AMERICAN UNIVERSITY 2021 CAMPUS PLAN

Comprehensive Transportation Review

Including: Addendum 1 (October 28, 2020)

Addendum 2 (February 4, 2021)

Figure 2-4: Transit Network & Shuttle Routes

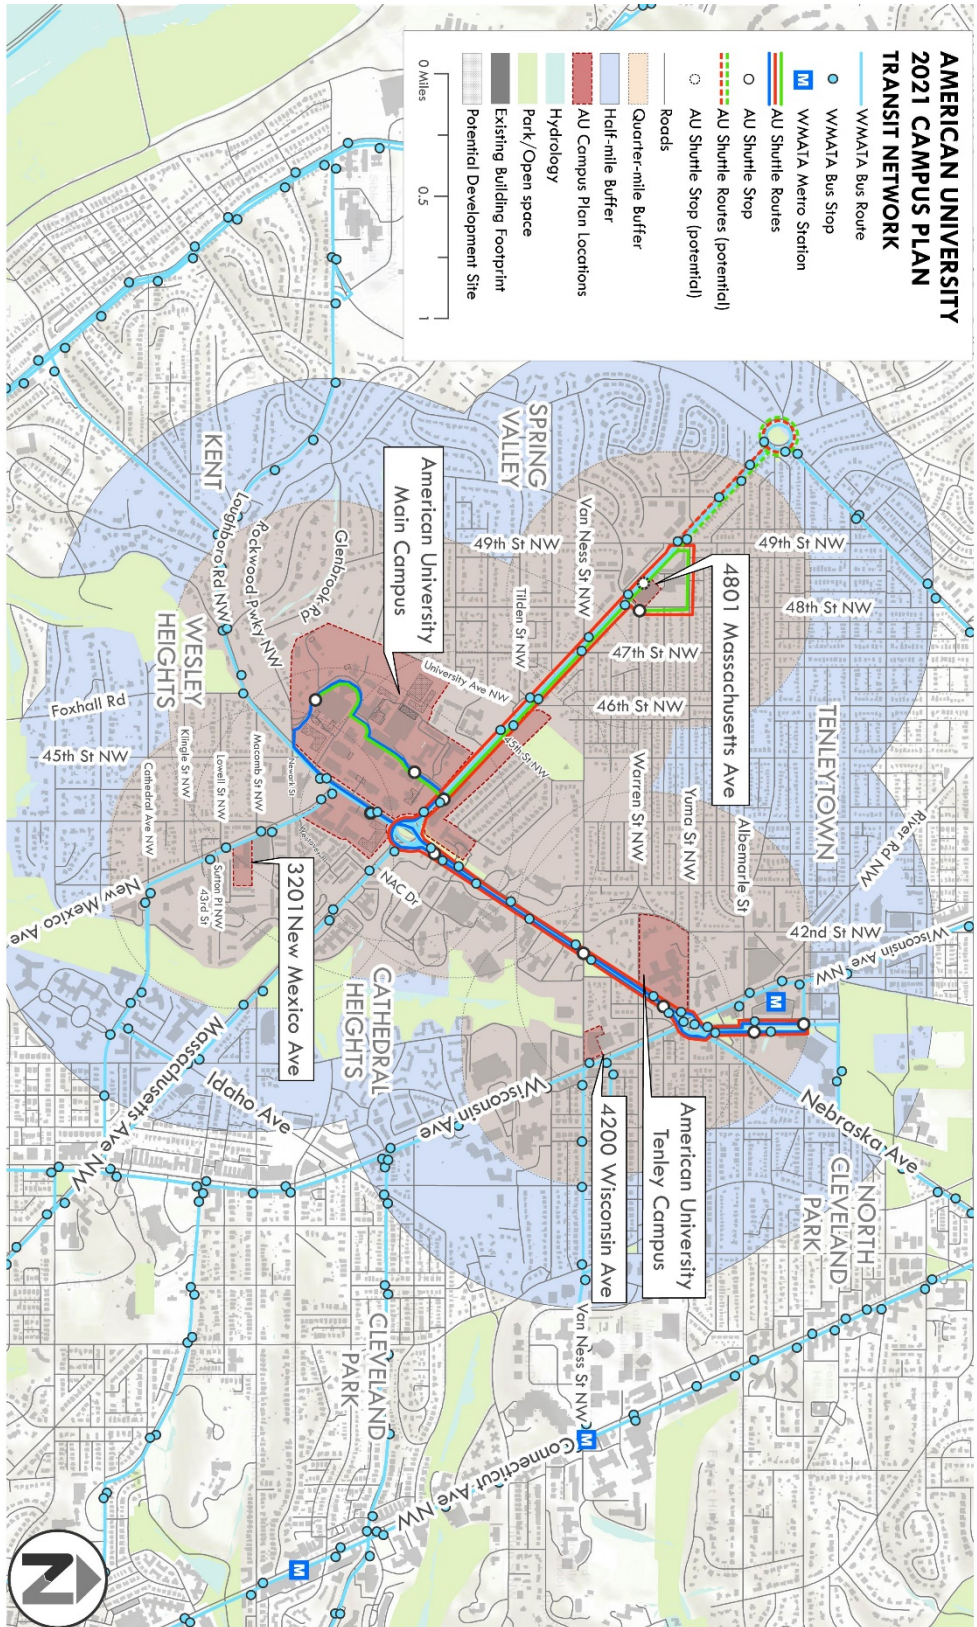
- a. The final sentence of the second paragraph has been updated as follows: “The 2021 Campus Plan does not include any proposed changes to the University shuttle service routes; **however, at the request of ANC3E, AU is currently pursuing a change to the location of the Spring Valley Building bus stop on the Red Route from 48th Street, NW to in front of 4801 Massachusetts Avenue, NW to alleviate the need for shuttles to utilize the neighborhood streets.**”
- b. Figure 2-4 has been updated to illustrate the proposed route and stop location.

Figure 3-3: Proposed Campus Circulation

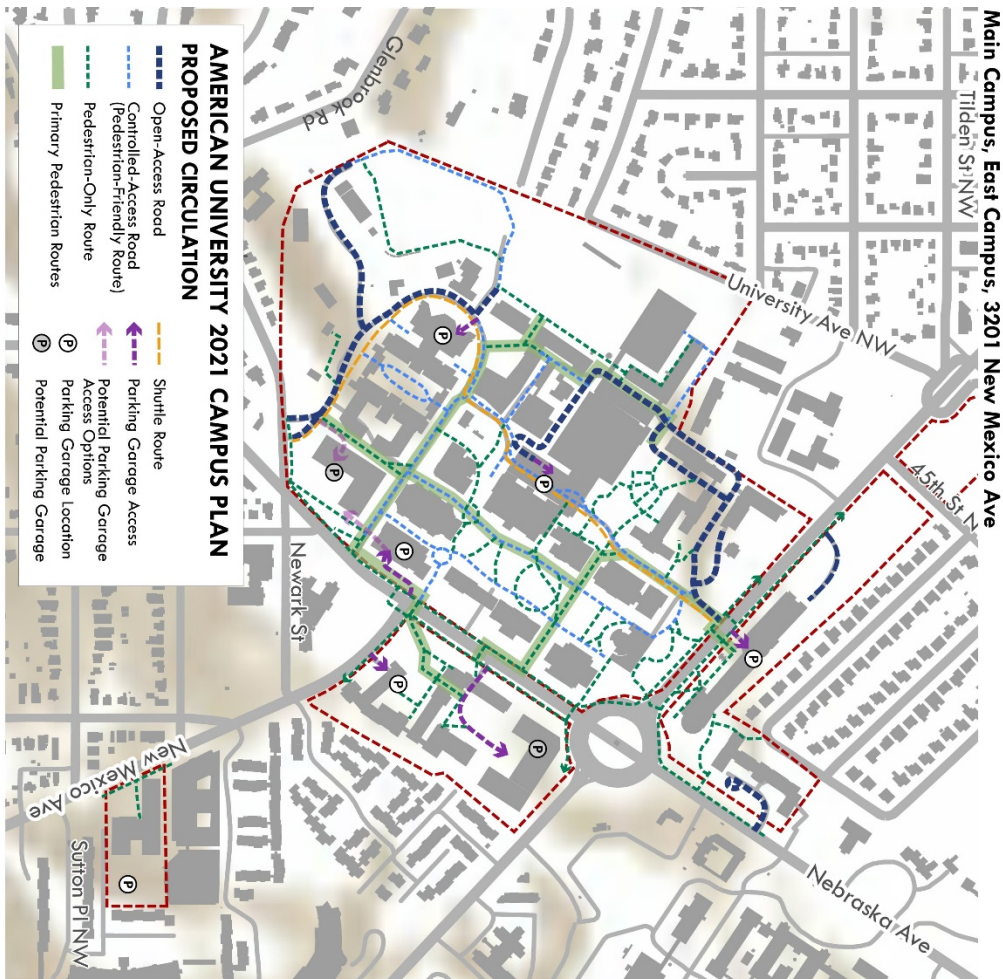
- a. Figure 3-3: Proposed Campus Circulation has been updated to reflect access options associated with the potential below-grade parking on Site 11/12. The preceding paragraph on page 3-21 has been updated as follows: “**In addition, as discussed in the 2021 Campus Plan, garage access options for potential below-grade parking at Site 11/12 will be subject to further review and consideration at the time of further processing.**”
